SUBJECT: SUMMARY OF OCTOBER 19, 2021, MEETING WITH NORTHERN STATES POWER COMPANY, DOING BUSINESS AS XCEL ENERGY, RELATED TO A THE LICENSE AMENDMENT TO EXTENDED THE ALLOWED OUTAGE TIME FOR THE VERTICAL MOTOR DRIVEN COOLING WATER SYSTEM PUMP (EPID L-2021-LLA-0187)

CL Simplified Diagram

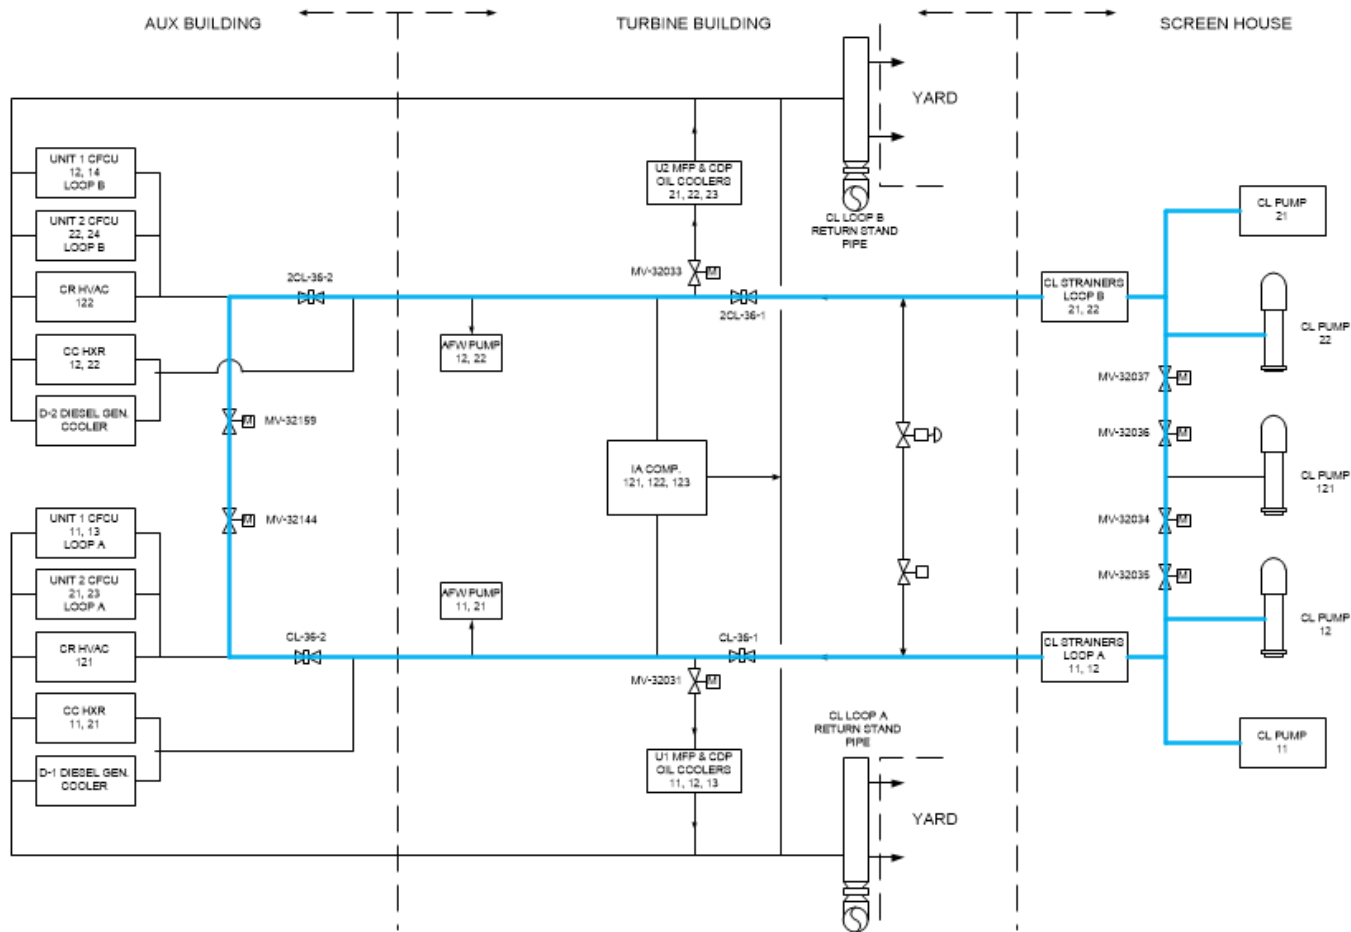
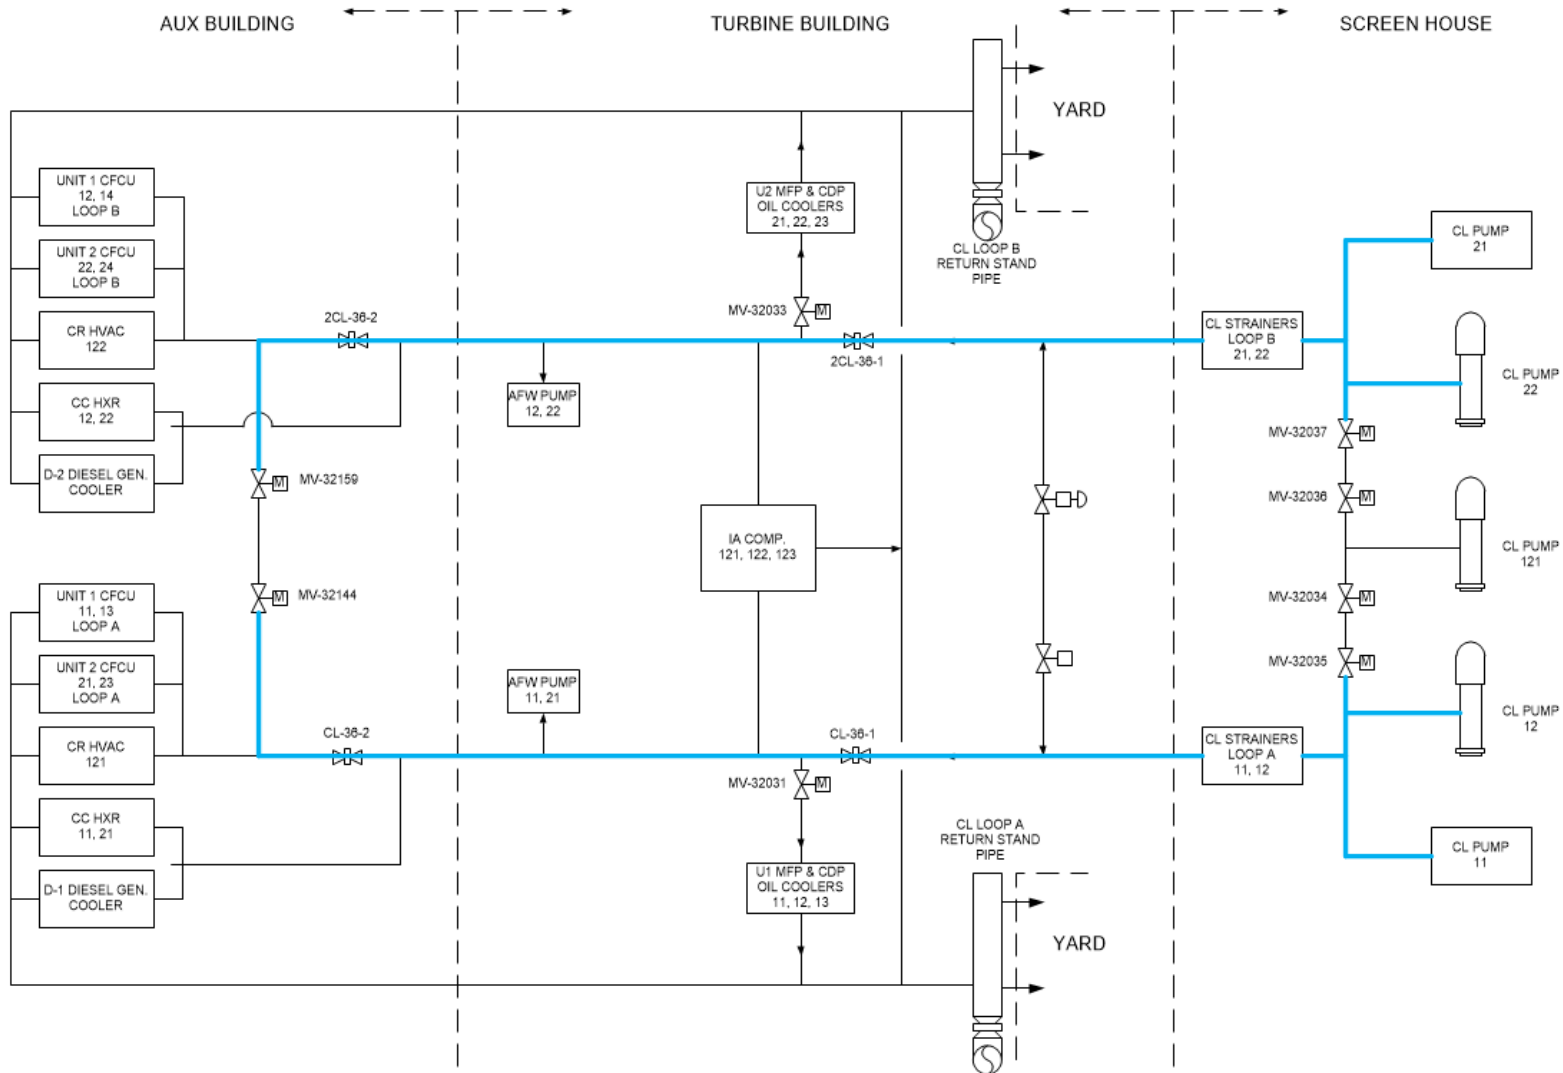
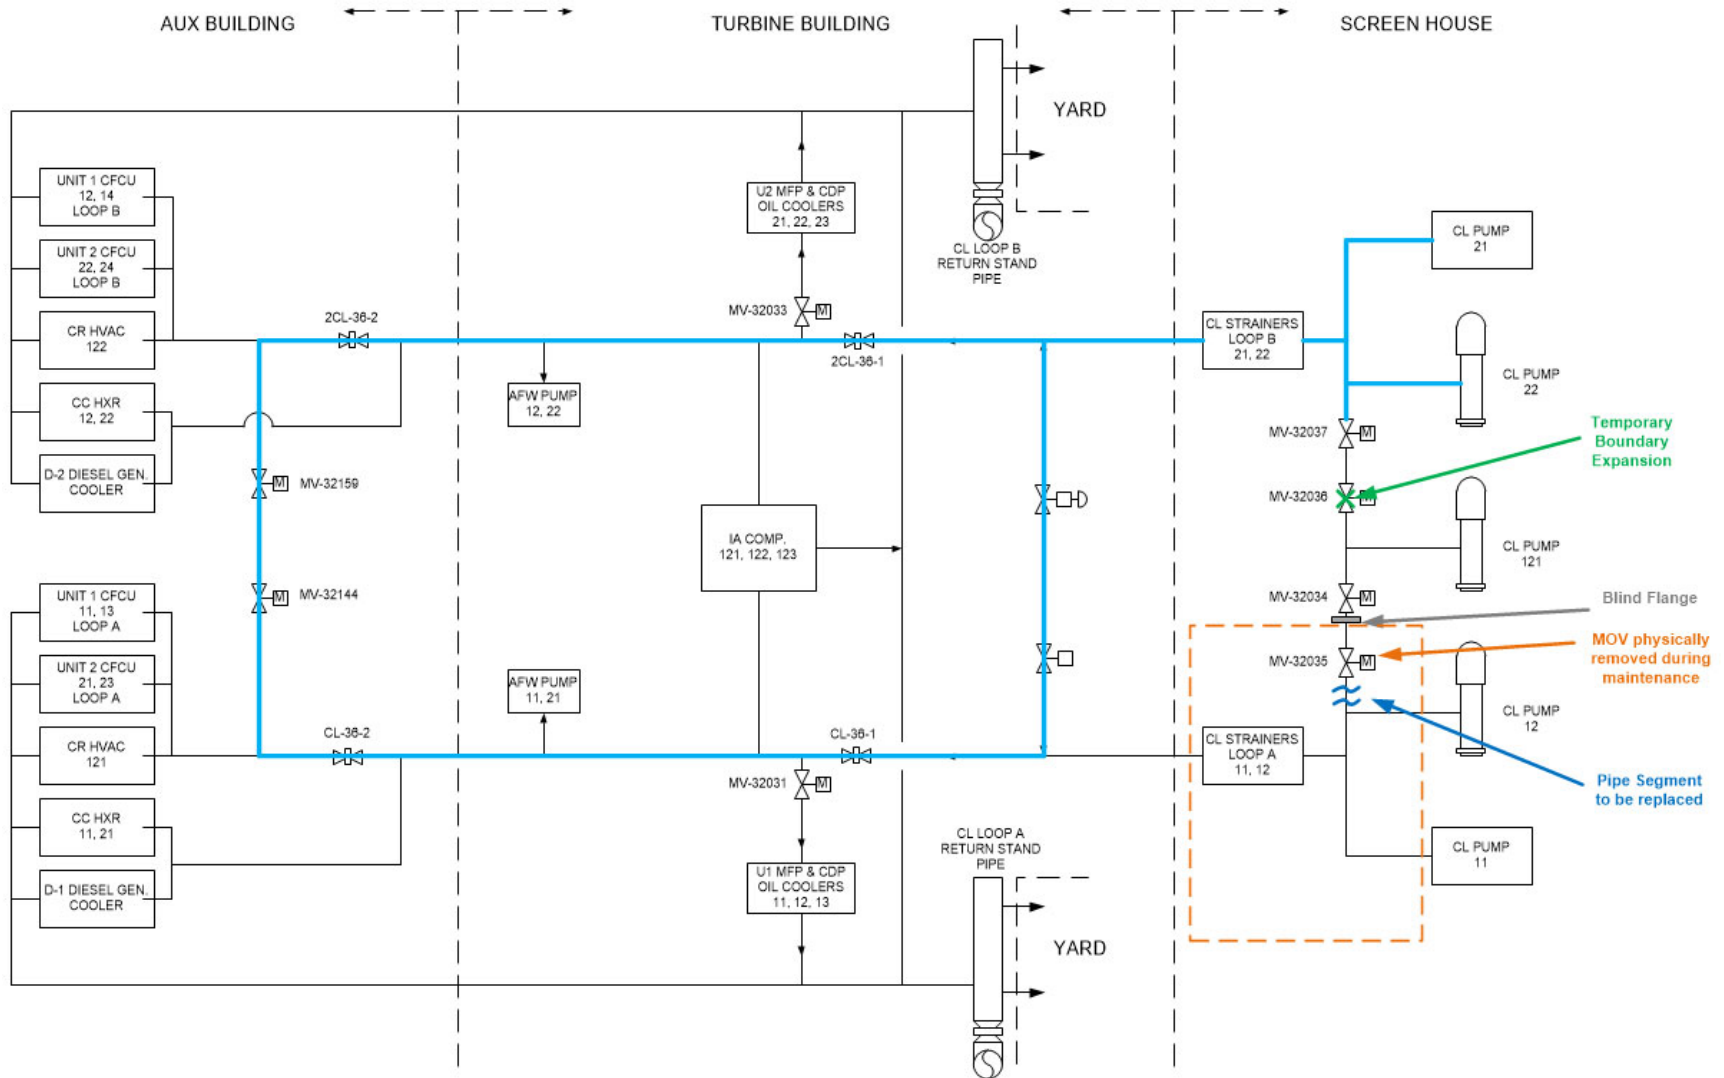
The licensee presented information regarding planned maintenance on CL system piping that will be replaced because the piping has indications of microbiologically induced corrosion (MIC). The licensee presented simplified diagrams (Enclosure 2) of the CL system and described the planned maintenance and contingency plans to potentially install a blind flange if the existing valves leak. The NRC staff queried the licensee on the availability of the back-up pump (pump 121 in the simplified diagram in Enclosure 2) during the maintenance. The licensee explained that during the maintenance the back-up pump would not be available. The NRC staff asked the licensee how long they estimated the maintenance would take. The licensee stated that the maintenance is anticipated to take approximately 5 days per unit if the contingency of installing the blind flanges was necessary. The NRC staff queried the licensee on the risk informed completion time (RICT) permitted by TS LCO, Condition B.3, and the licensee indicated that the RICT they have calculated is 30 days for this configuration.
